BDCP Comments  
Ryan Wulff, NMFS  
650 Capitol Mall, Suite 5-100  
Sacramento, CA 95814

**SUBJECT: Comments on the Bay Delta Conservation Plan and Environmental Impact Report/Environmental Impact Statement**

Figure 1. Projected Inflow to Trinity, Shasta, Oroville, and Folsom Reservoirs – NAA, NAA-ELT and NAA-LLT

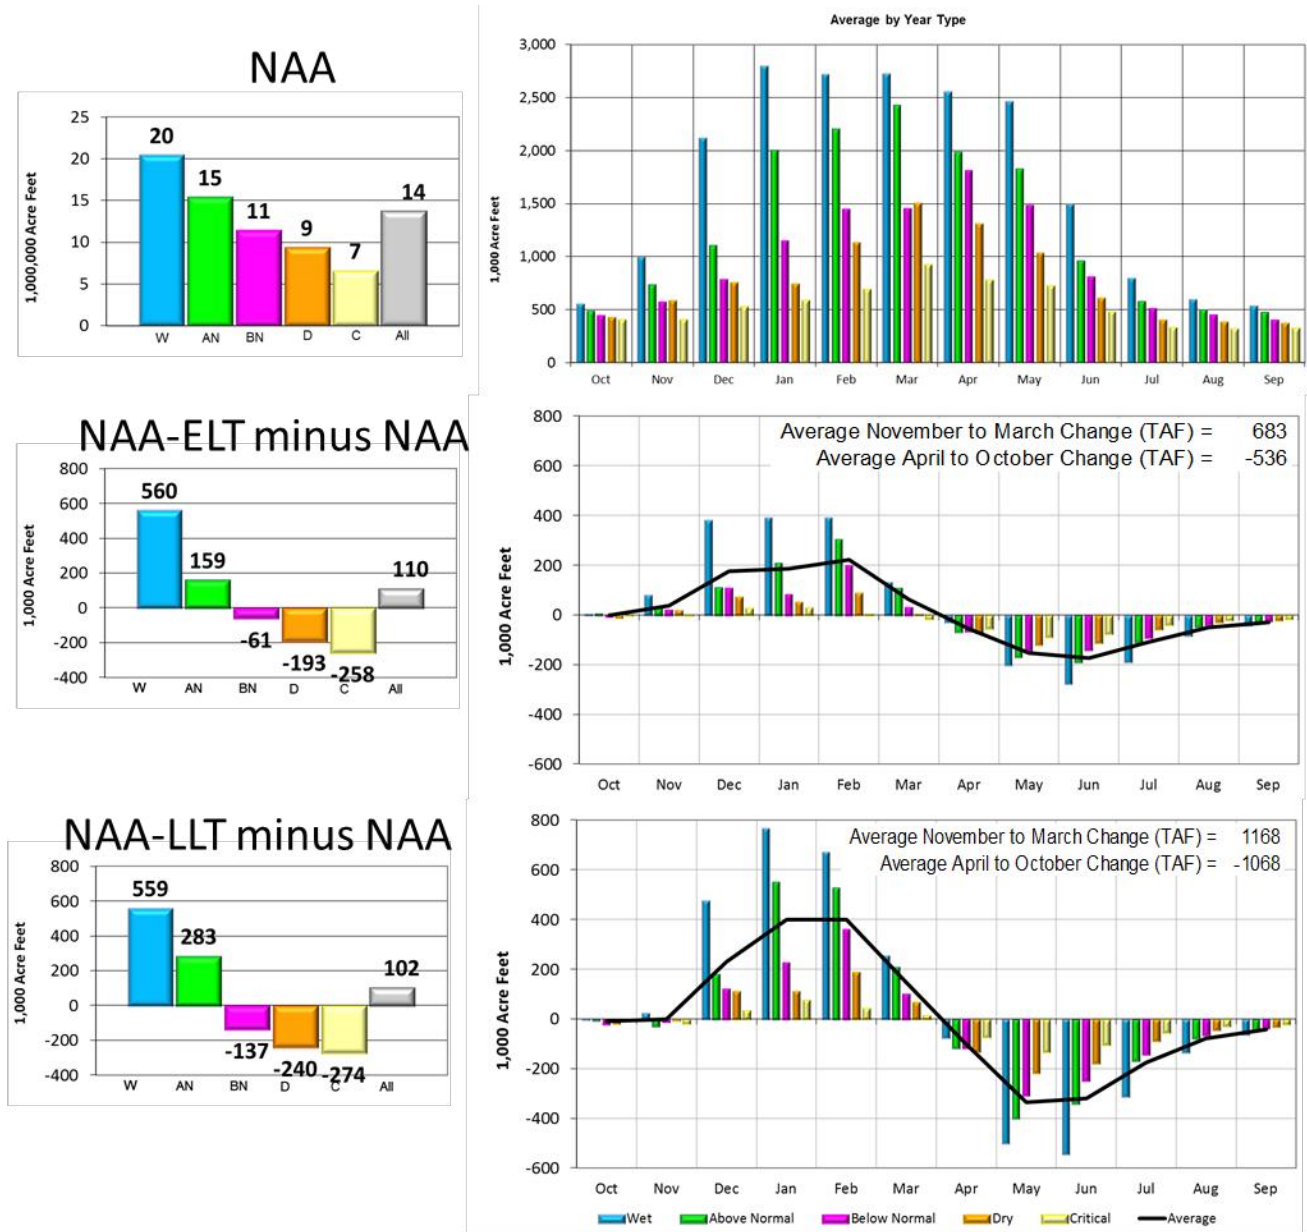
The significance of changed hydrology between the three without project baselines is illustrated in Figure 1 below. The figure illustrates the projected combined inflow of Trinity, Shasta, Oroville, and Folsom Reservoirs under the three NAA baselines. Numerous modeling projections for climate change have been developed, and in this BDCP group of Scenarios Trinity, Shasta, and Oroville inflow are projected to increase overall, but with a

In our opinion, the CalSim II depicted operations that incorporate climate change are not reasonably foreseeable and do not represent a likely future operation of the CVP/SWP. Although an argument is typically made that these study baselines will be used in a comparison analysis with Project Alternatives tiering from these baselines, we believe that the depicted operations do not represent credible CVP/SWP operations and we have no confidence in the results and they are inappropriate as the foundation of a Project Alternative. As such, although the modeling approach may provide a relative comparison between equal foundational operations, we are apprehensive to place much confidence in the computed differences shown between the NAA and Project Alternative Scenarios.

Figure 2. Projected Shasta Reservoir Carryover Storage, NAA, NAA-ELT and NAA-LLT

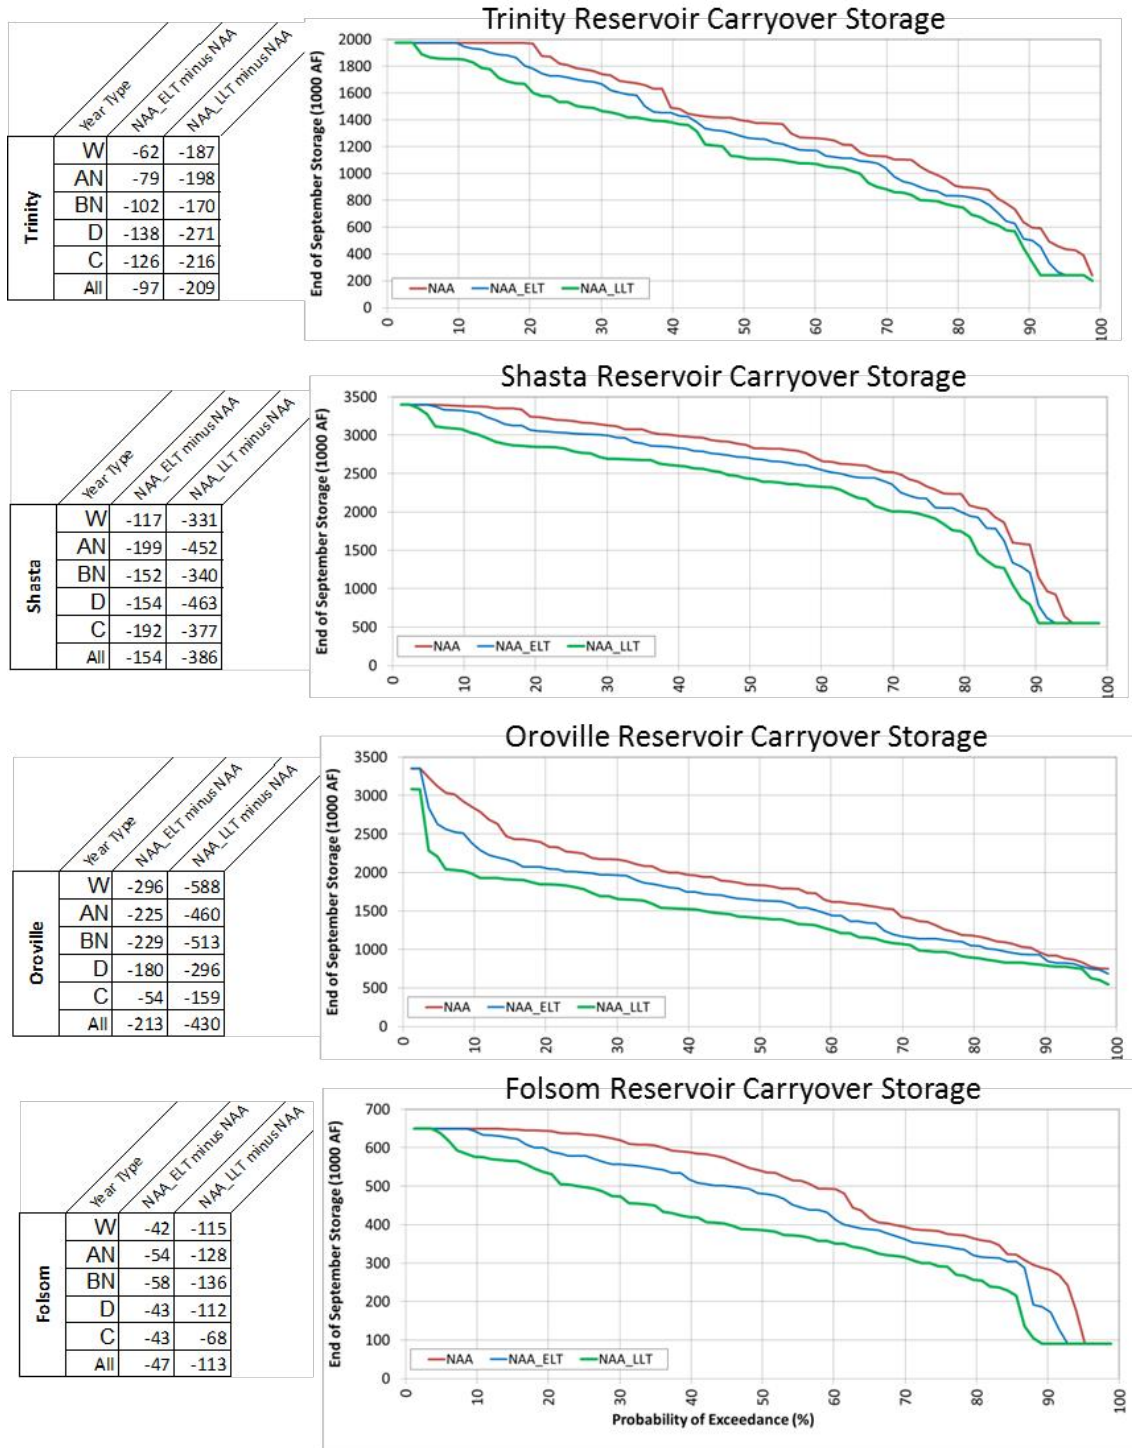
For upstream CVP and SWP reservoirs the assumed shift of inflows due to climate change (Figure 1) along with a continuing need to satisfy exports demands significantly affects carryover storage. The CVP and SWP simply cannot satisfy water demands and regulatory criteria imposed on them in the NAA-ELT and NAA-LLT modeling scenarios.

Figure 2 illustrates the typical change in carryover storage as shown for Trinity, Shasta, Oroville, and Folsom Reservoirs. The relatively high frequency (approximately 10% of time) of minimum storage occurring at CVP reservoirs illustrates our questioning of credible operations in the studies.

**Figure 3. Projected Inflow to Millerton Lake –NAA, NAA-ELT and NAA-LLT**

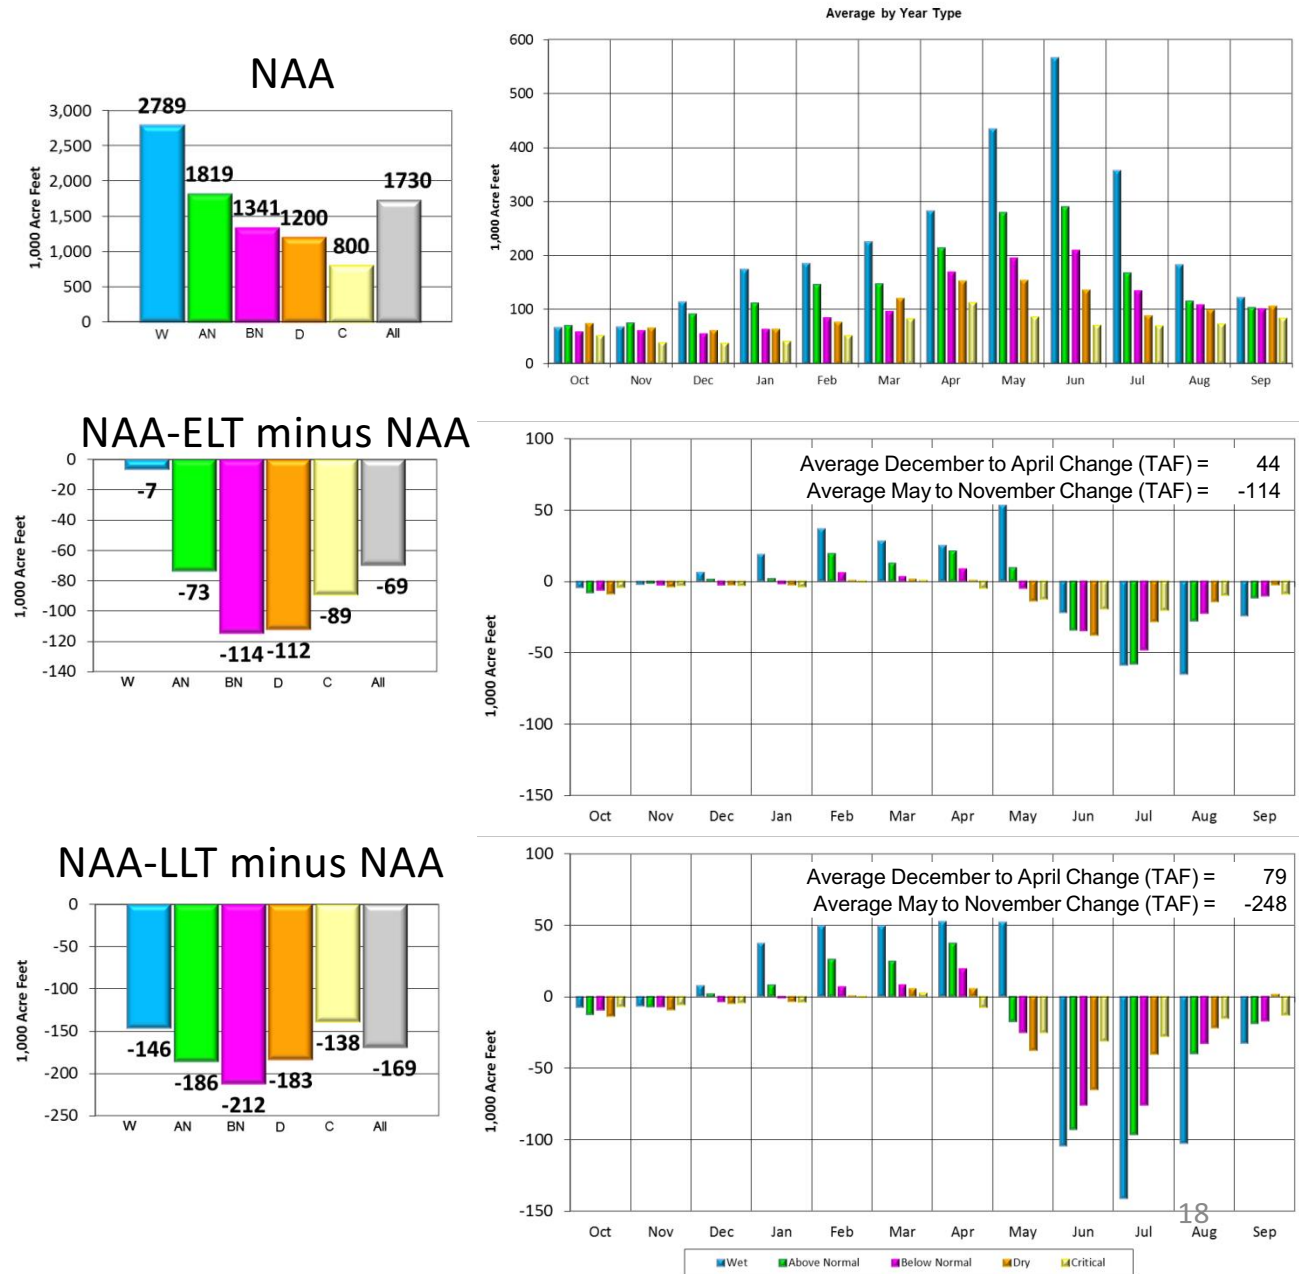
San Joaquin Valley reservoirs are depicted with an overall decrease in annual runoff with some shifting of runoff from spring to winter, but mostly just decreases in spring runoff due to a decline in snowmelt runoff during late spring<sup>5</sup>. Figure 3 illustrates the assumed effects of climate change upon inflow to Millerton Lake.

Inflow to Millerton Reservoir in this version of CalSim is input in three separate time series for purposes of depicting the hydrology of potential upper basin reservoirs. Climate change hydrology was inconsistently incorporated at Millerton Reservoir and misapplied to the water supply and flood control operations. The result is an unrealistic operation for river releases and canal diversions. Figure 3 illustrates the projected ELT and LLT changes in Millerton Reservoir inflow incorporated in these studies. On face value of the input data, regardless of Friant Dam river release assumptions the effect of climate change at Millerton Lake will affect water deliveries.

**Figure 4. Millerton Reservoir Carryover Storage, NAA, NAA-ELT and NAA-LLT Scenarios**

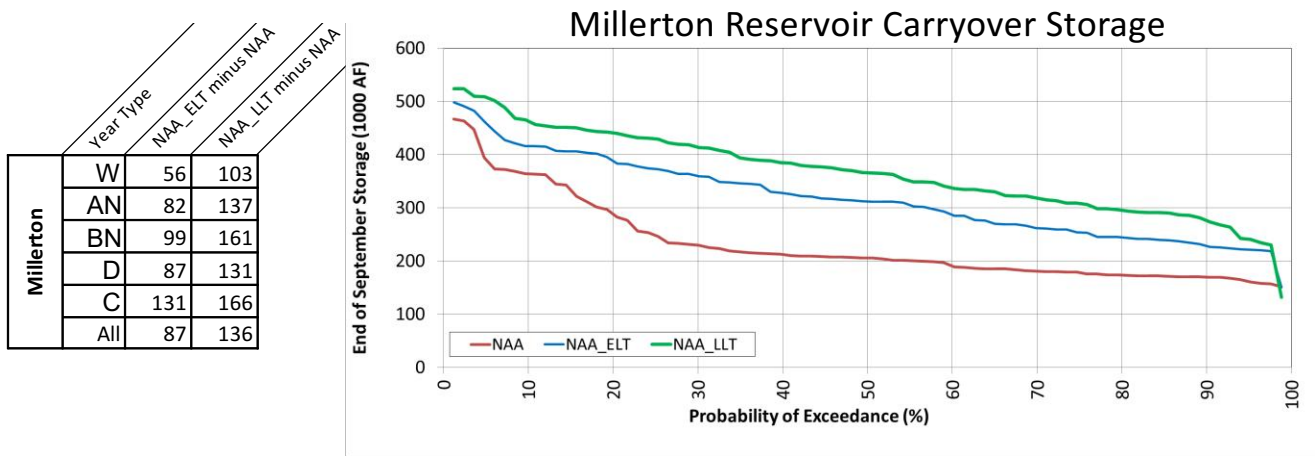
Evidence of the inconsistent inflow problem is shown in the result for the comparison of carryover storage of Millerton Reservoir under the NAA, NAA-ELT, and NAA-LLT Scenarios (Figure 4). Carryover storage is higher in the ELT and LLT Scenarios due to climate change effects to inflow incorporated in reservoir operations but not in the computation of water supply deliveries. Thus, water deliveries are suppressed and the reservoir ends the year with greater storage.

**Figure 12. Temperature Exceedance Sacramento River at Bend Bridge Existing, No Action Alternative, ELT**

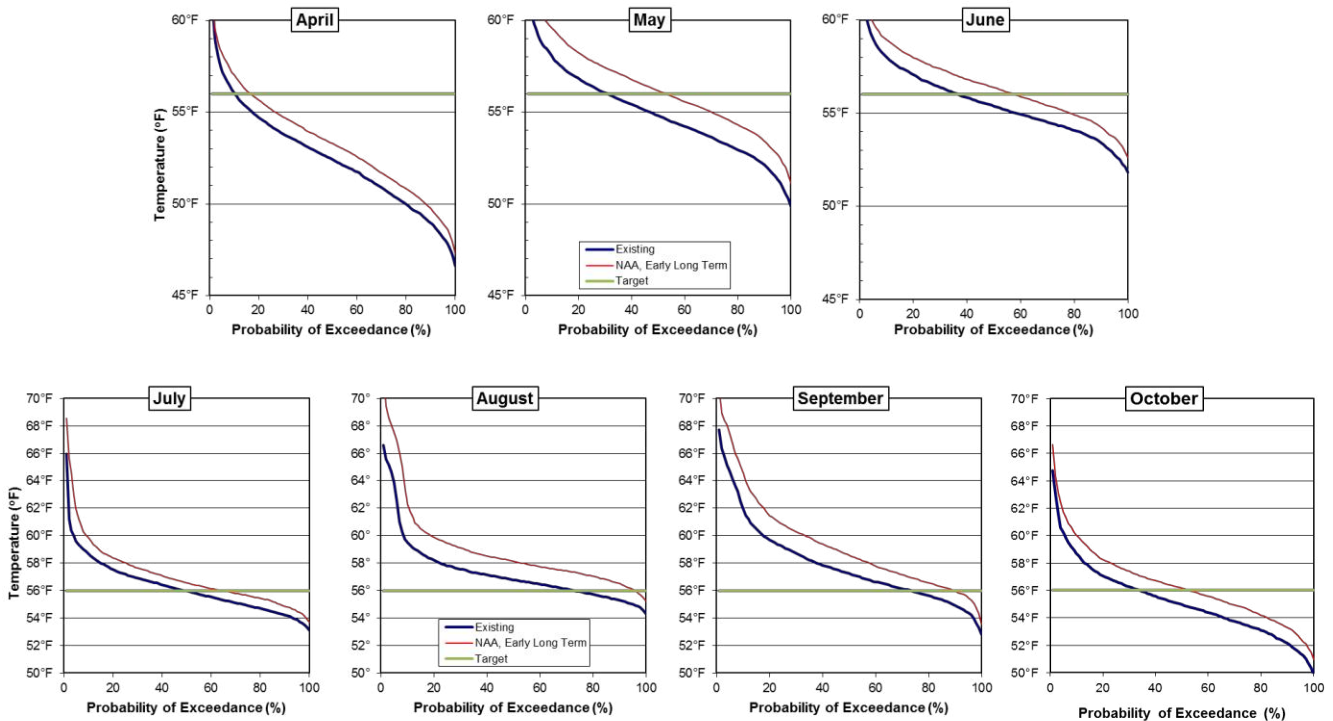
River temperature model and results for the No Action and Alternatives. Each BDCP Alternative used temperature target criteria for the upper Sacramento River as is used for the Existing Conditions modeling scenario. Equilibrium temperatures, a calculated model input that approximately depicts the effective air temperature for interaction with water temperature in the model, between Shasta and Gerber are increased by an annual average of 1.6°F for the ELT Scenarios and by 3.3°F for LLT Scenarios. Figure 12 contains monthly exceedance probability charts of temperature at Bend Bridge in the Sacramento River for April through October for the Existing Conditions and NAA-ELT Scenarios. There is about a 1 degree increase in average monthly temperature for the April through October period. Figure 13 contains similar information as Figure 12, but compares modeling results for the NAA-LLT and Existing Conditions Scenarios, there is often a 2°F increase in the NAA-LLT relative to Existing Conditions.

The increase in equilibrium temperatures combined with decreases in storage would lead to water temperature conditions that would likely not achieve the assumed objectives. Figure 12 and Figure 13 illustrate an increase in the probability that a water temperature target of 56°F would be exceeded at Bend Bridge under both the NAA-ELT and NAA-LLT Scenarios. The probability of exceedance increases approximately 5% to 20% depending on the month for the NAA-ELT Scenario and approximately 10% to 40% for the NAA-LLT Scenario.

Figure 19. NDD, Bypass Requirement, Bypass Flow, and Excess Sacramento R. flow for Alt 4-ELT

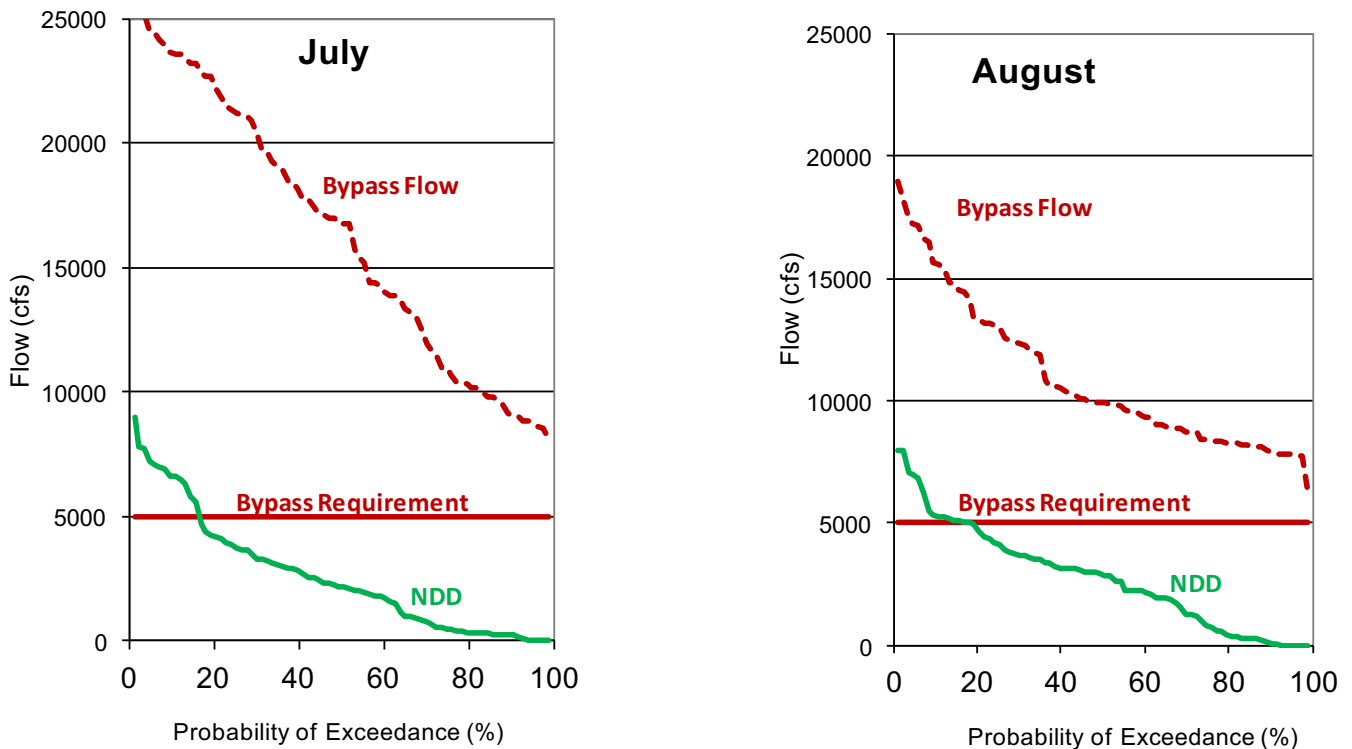
Sacramento River flow below the North Delta Diversion (NDD) must be maintained above the specified bypass flow requirement, therefore the NDD rates are limited to the Sacramento River flow above the bypass requirement. Due to an error in CalSim II that specifies an unintended additional bypass requirement, modeling performed for the BDCP EIRS often bypasses more Sacramento River flow than is specified in the BDCP project description. This error has been fixed in the most recent public releases of CalSim II, but BDCP modeling has not been updated to reflect these fixes. Figure 19 contains exceedance probability plots showing the Sacramento River required bypass, Sacramento River bypass flow, NDD, and excess Sacramento River flow to the Delta as modeling for BDCP. As can be seen in Figure 19, the bypass flow is always above the bypass requirement in July and August. The BDCP version of CalSim sets a requirement for Sacramento River inflow to the Delta needed to satisfy all Delta flow, quality, and export requirements, this requirement should be removed when modeling the NDD.

Figure 22. Alt 4-ELT North Delta Diversion Versus South Delta Diversion for July, August, and September

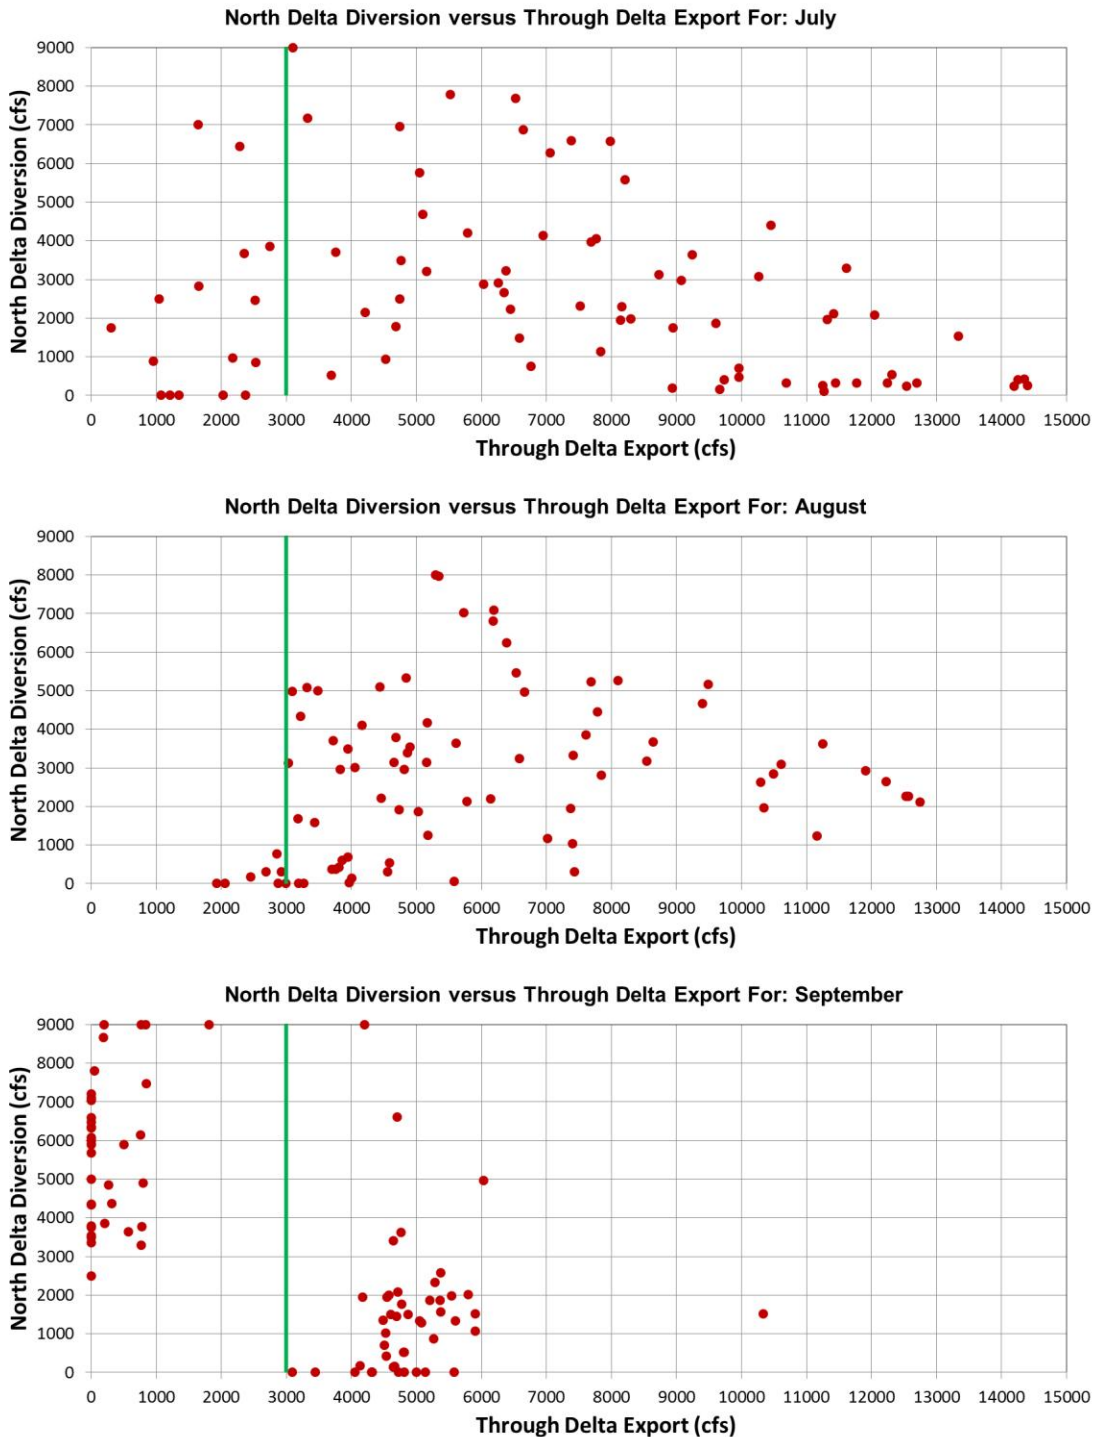
Figure 22 contains figures for July, August, and September for Alt 4-ELT that plot NDD against SDD. In the months of July to September SDD are occasionally very high, exceeding 14,000 cfs in July, with minimal NDD. This occurs due to outdated model code that imposes an instream flow requirement in Sacramento River flow below Hood in excess of the bypass criteria prescribed in the BDCP. There are numerous occurrences when bypass flows prescribed in the BDCP are exceeded and SDD are higher than expected. On the other hand, there are also many times when NDD are above minimum pumping levels and SDD are below the BDCP prescribed 3,000 cfs threshold indicated by the green line in Figure 22. For unknown reasons, the model code requiring SDD to be greater than 3,000 cfs before NDDs occur from July through September is deactivated in the BDCP modeling of this Alternative.
